ISSUE: Request for revisions to previously approved plans to Demolish/Capsulate and for Alterations at 10 Duke Street

APPLICANT: 10 Duke Street Owners LLC

LOCATION: 10 Duke Street (formerly 2 Duke Street, building A)

Figure 5: Belle Pre Bottle Company, 1902, Henry at Madison, Alexandria

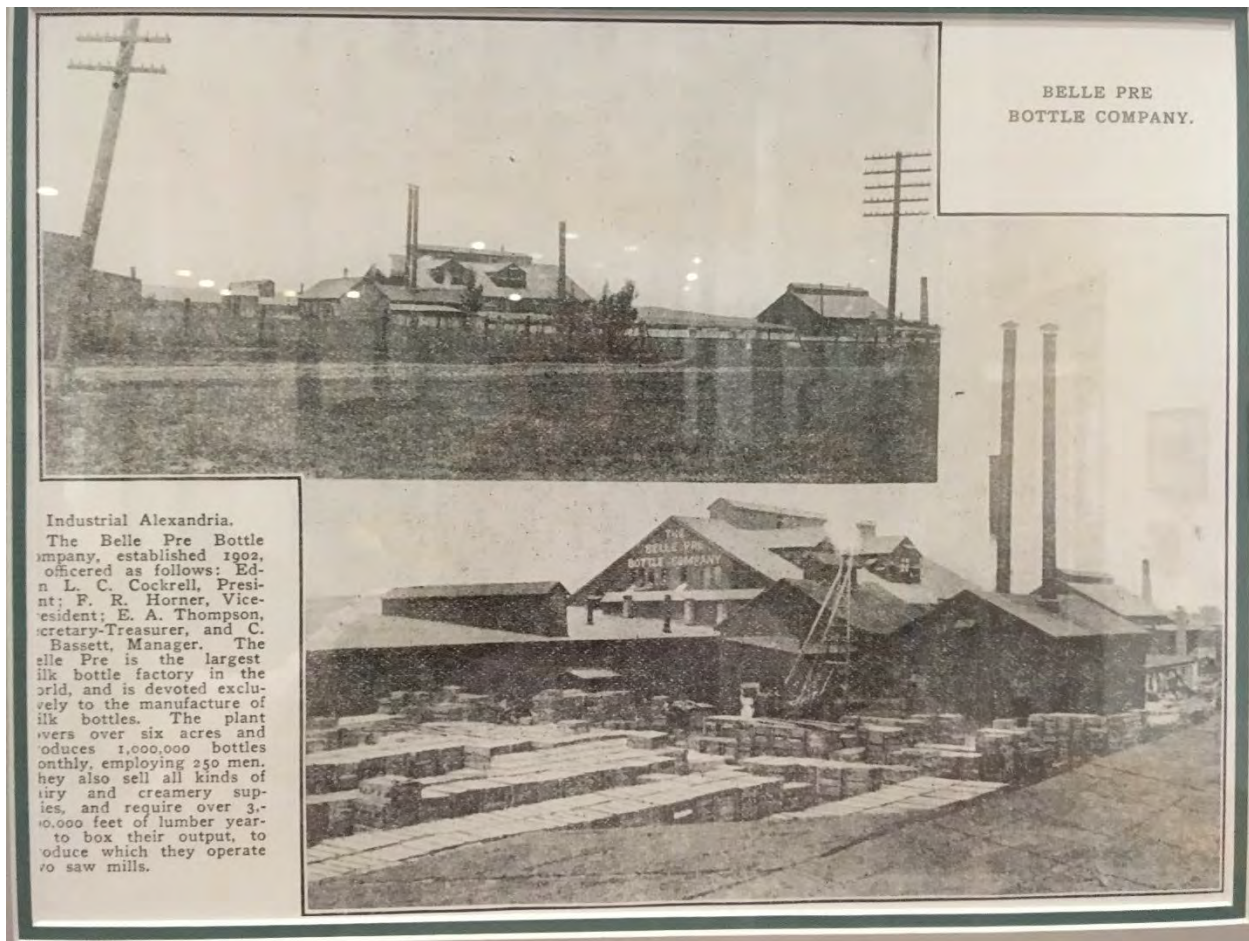
Staff believes the overall design is appropriate for the rehabilitation and adaptive reuse of this historic warehouse. As noted in Figures #2-5, the roof monitor is a form that was used extensively in historic factory and warehouse buildings to get light to the interior and promote ventilation, with numerous examples in Alexandria. In this case, it is also used to integrate the mechanical equipment with the overall form of the building, as recommended in the BAR’s *Design Guidelines*. The existing chimney, which is a traditional industrial feature, provides a vertical punctuation for the 101’ long building. Staff was unable to find clear evidence of the original roof material but standing seam metal, as is being proposed, is the most likely from this period. Windows in the original openings are painted wood, as required by the BAR in the previous approval but windows and doors in the larger openings and in the roof monitor will be steel or metal clad. A distinction is also between new and existing openings by the use of steel channel lintels above the larger openings, as these would have been far too wide for a masonry arch. Staff has no objection to the projecting and hanging signs proposed but there was no detailed information provided in the application and these will have to be approved separately, possibly administratively if the Criteria for the Administrative Approval of Signs are met.

1. The proposed roof monitor, recommended by staff to incorporate the rooftop mechanical equipment into the overall building design, has made the building 1'-4" too tall for the W-1 zone without obtaining a Special Use Permit. Staff is working with the applicant to adjust some grades along the west wall and to lower the roof monitor a few inches to comply. See examples of historic roof monitors in Figures #2-5 and the historical photo #2 of this site on the applicant's sheet A08.
